Constellation
Heritage
4700 Models

Western Star
Service Bulletin

General Information

Fig. 1, Old Deaeration Hose Routing (typical)

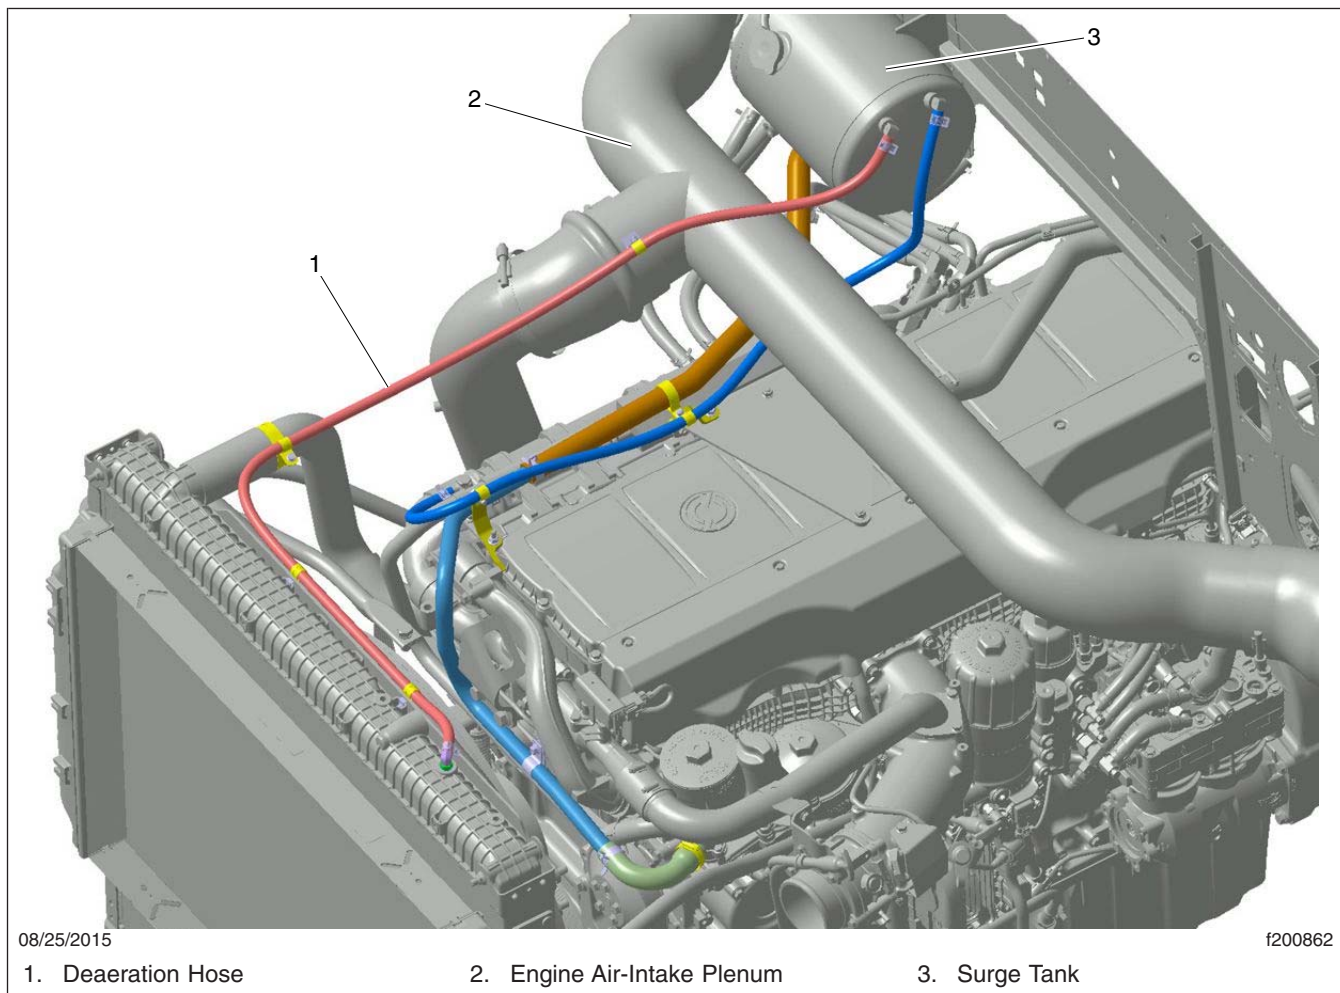
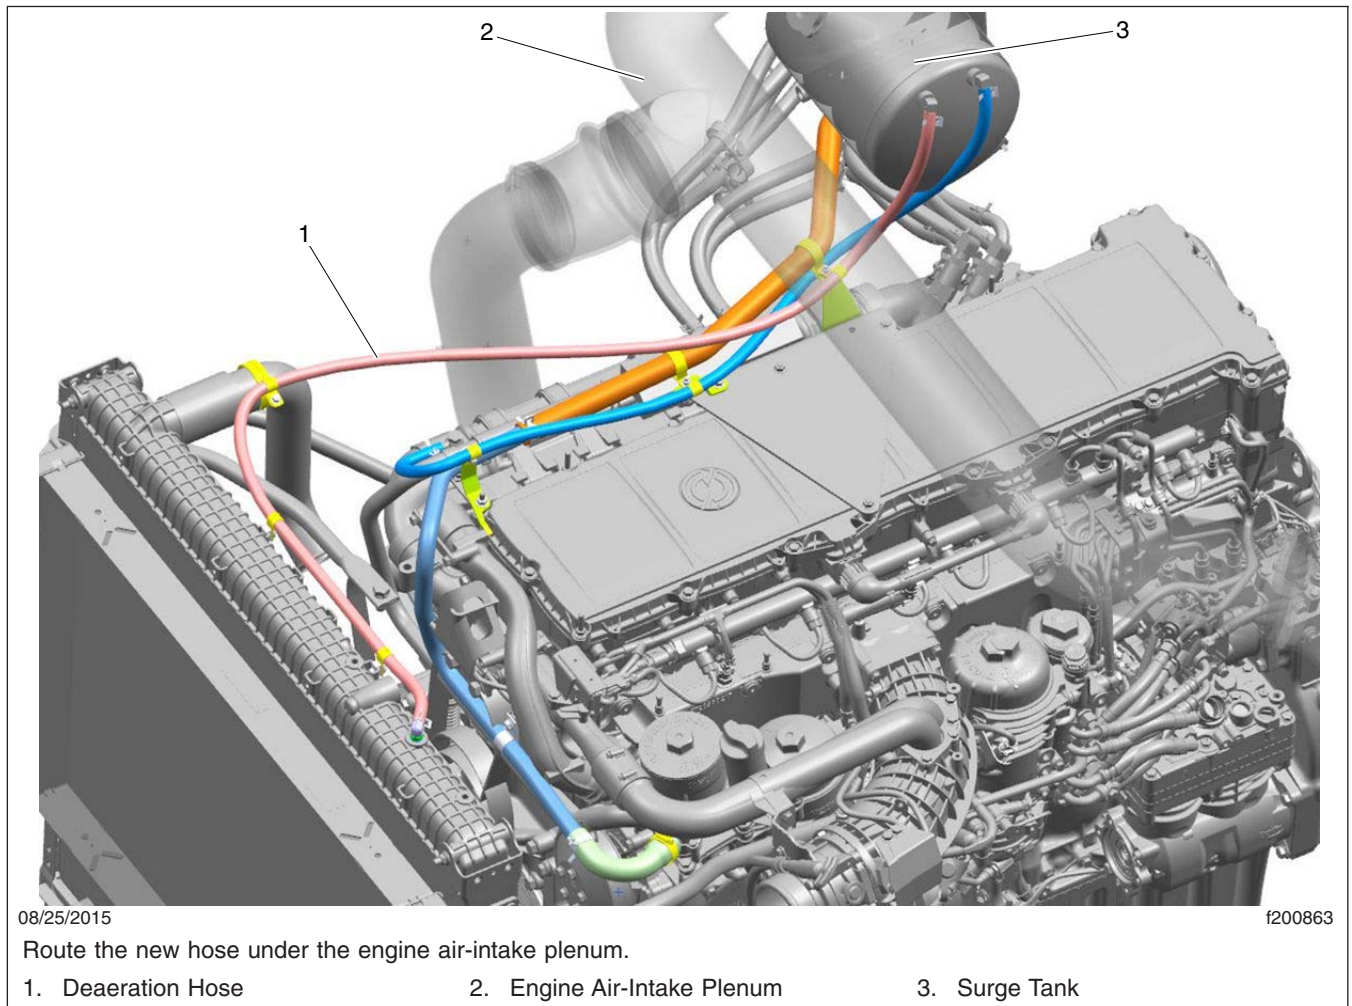
Interference between the hood insulation, the surge-tank deaeration hose, and the engine air-intake plenum has been reported on some Western Star 4800 and 4900 models, with Detroit engines, built between start of production and June 15, 2015. This interference may cause a leak or damage to the affected components.

The hose routing has been revised at the manufacturing plant to address this issue. There are no part number changes. If a leak or rubbing issue is found, follow the instructions below to repair and reroute the hose. The replacement hose will be longer to accommodate the new routing.

3. Drain the cooling system enough to remove any coolant from the deaeration hose.
4. Remove the original hose and discard it.
5. Install the new hose. Route the new hose under the engine air-intake plenum and to the surge tank. Use available clipping locations as needed. Refer to [Fig. 2](#) for typical new hose routing.
6. Inspect the intake air plenum near the deaeration hose for damage. Repair or replace as needed.
7. Inspect the hood insulation in the area of the deaeration hose for damage. Repair or replace as needed.
